**CITY OF DOVER, DELAWARE
PLANNING COMMISSION
Monday, October 21, 2024 at 7:00 PM**

- [3.](#) C-24-02 Luther Village IV: Planned Neighborhood Design – Senior Citizen Housing Option on Babb Drive – Update on Waiver Request for Elimination of Rear Emergency Access: The Planning Commission on September 16, 2024 granted conditional approval of the Conditional Use Site Plan/Master Plan for the development of Luther Village Planned Neighborhood Design – Senior Citizen Housing Option consisting of up to 524 age-restricted apartment units in a total of nine phases and including approval of a series of Alternative Design Standards, Waiver Requests, and recommended approval of Subdivision Waiver Requests. Action was deferred on the Waiver Request for the Elimination of Rear Emergency Access. The Master Plan was previously established by Applications C-02-02 and C-13-03 and Luther Village Phases I, II, and III have been constructed. The plan for Phase IV consists of the construction of a three-story apartment building with 72 units (age-restricted) and associated site improvements. The plan also includes a Minor Subdivision to create a 2.79 acre+/- parcel for Phase IV from the overall 33.63

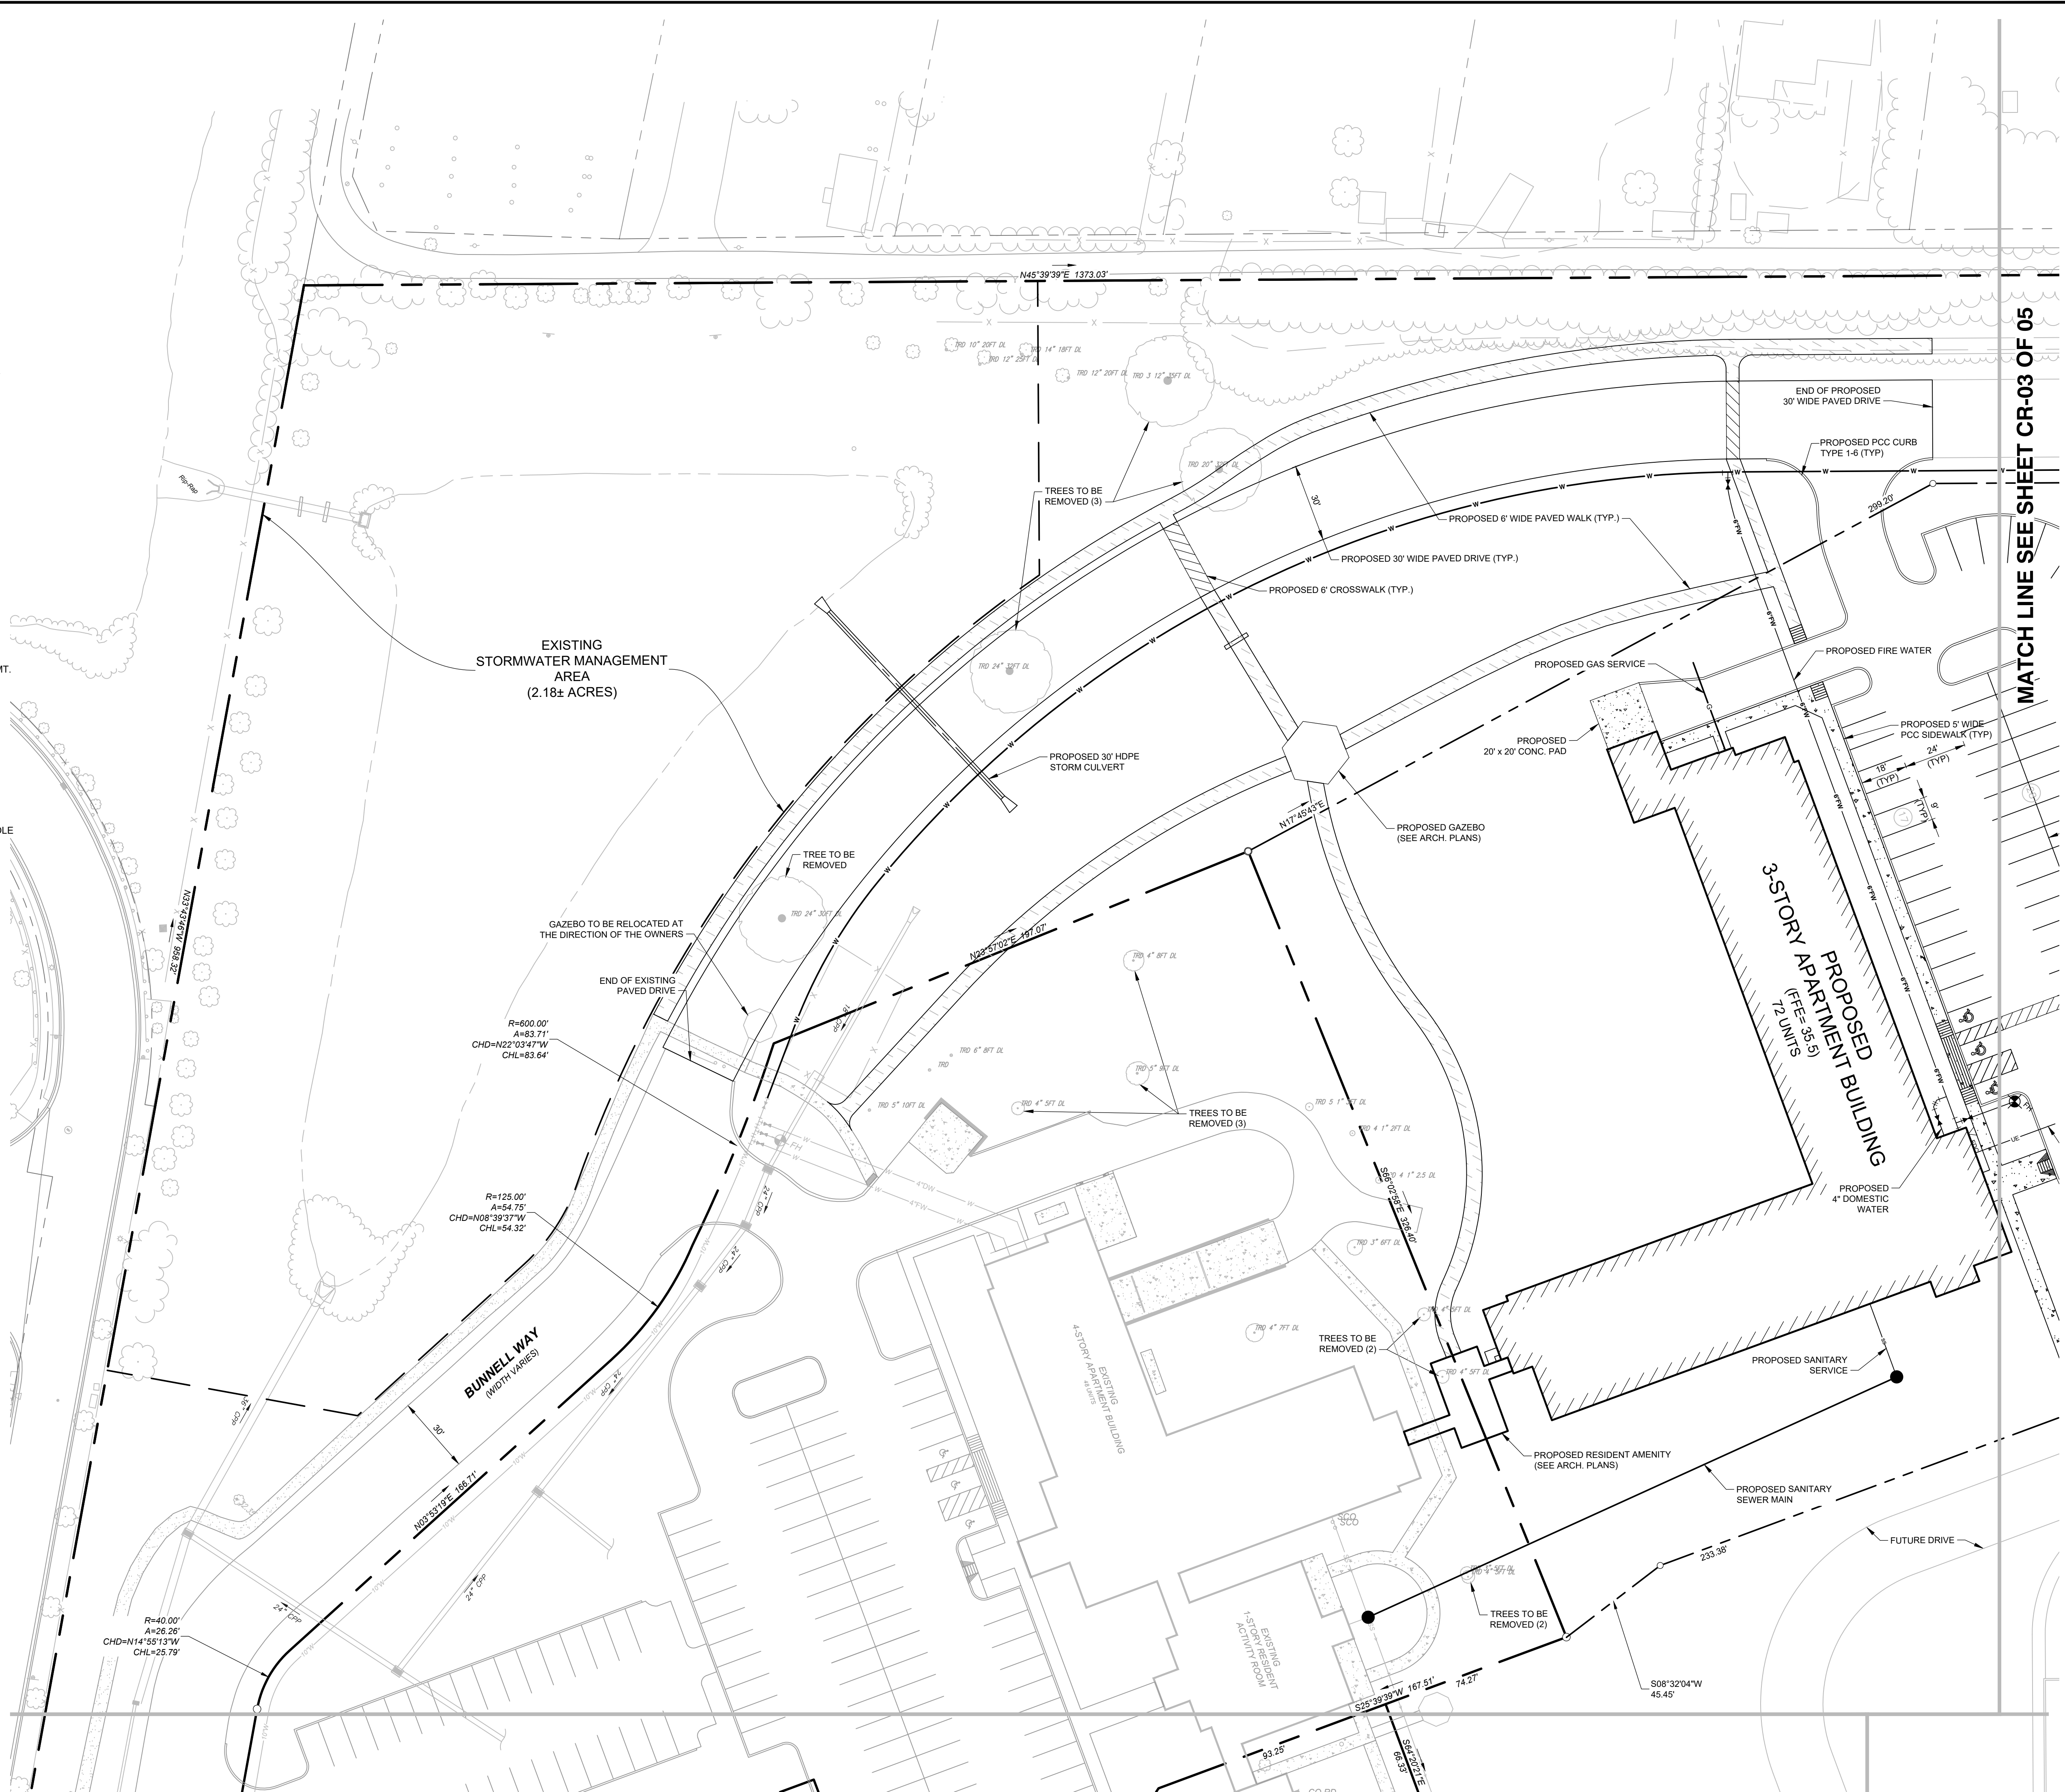
- j. Add tallies of Active Recreation Areas as existing, proposed, and overall.
- 10) Sheet CR-02 to CR-05:
- a. Setbacks: As a PND-SCHO a series of Alternative Design Standards were previously authorized and are being considered again. Show the distances from the proposed Phase IV building to the property lines.

DRAWING NUMBER: SP-01

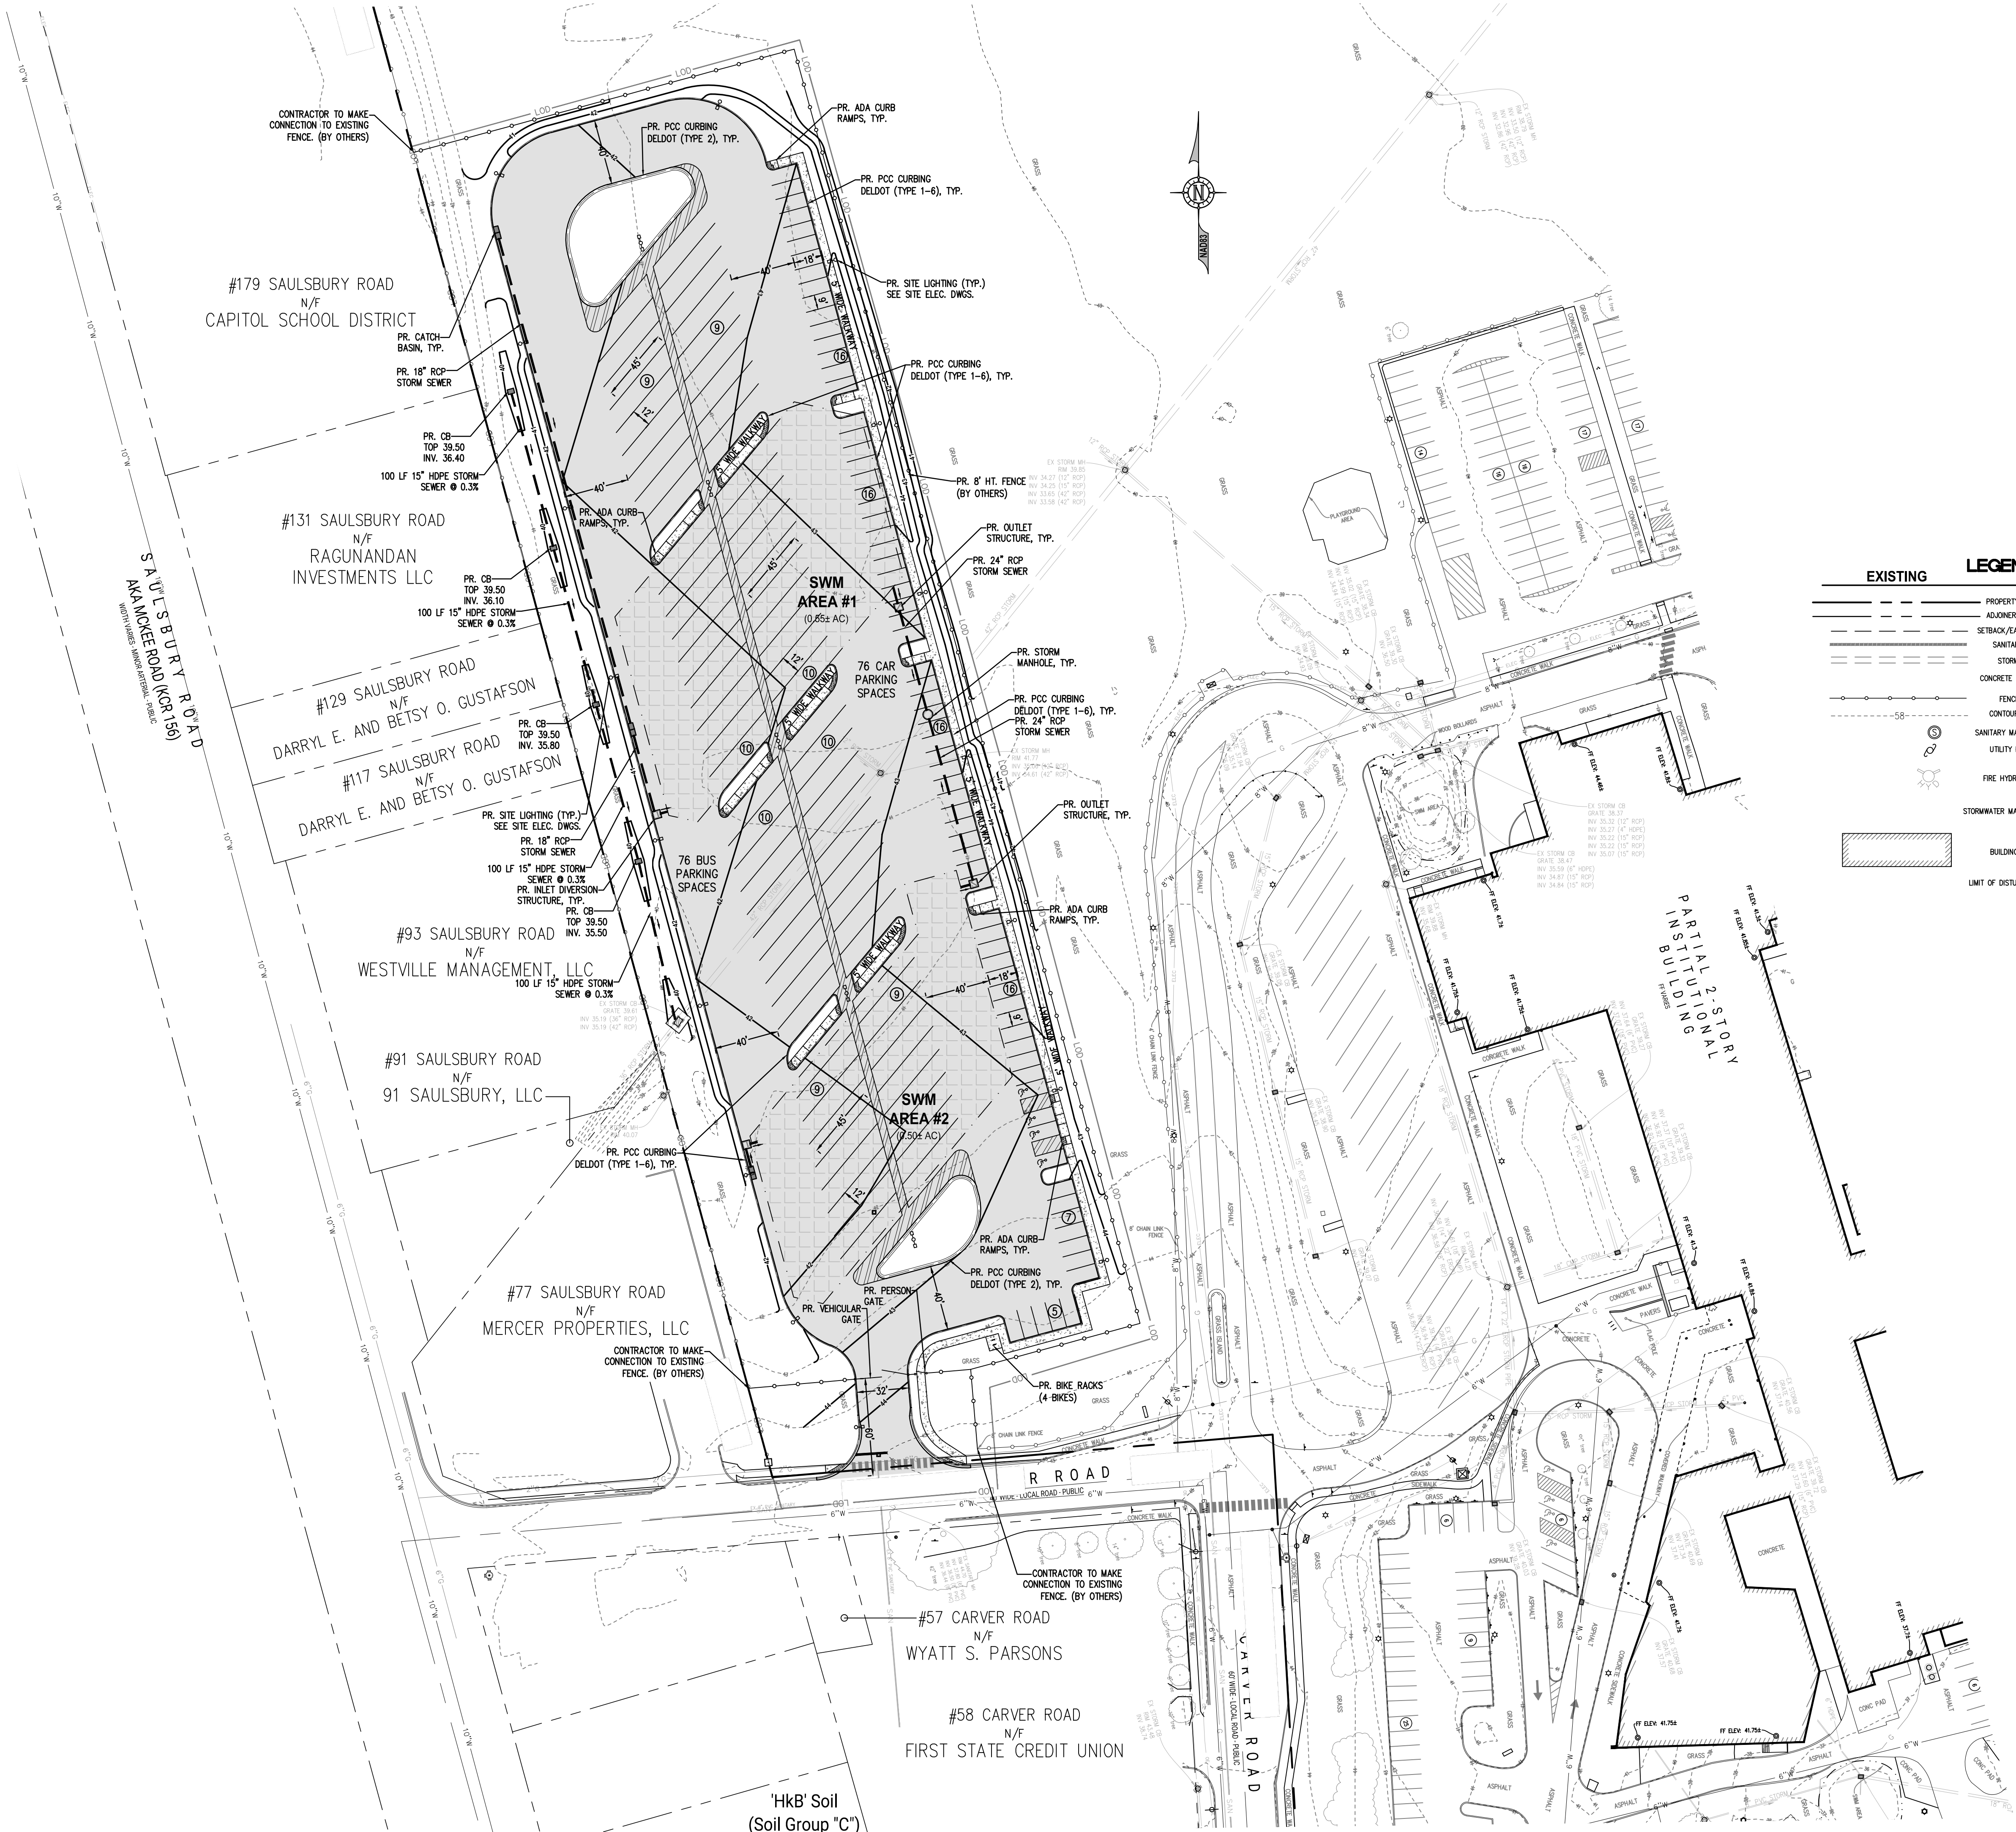
- 4) Cover Sheet SP-01 – Site Plan Overall Layout:
 - a) Show location of the COZ-1 zoning district boundary line on the drawing.
 - b) There are some missing unprinted areas in the street names.

- c) Add title of signee on behalf of owner.
 - d) In data column:
 - i) Add bicycle parking calculation.
 - ii) Check the size of Limit of Disturbance as listed here at 5.0 acres but 4.93 acres on Sheet LP-01. Revise all instances.
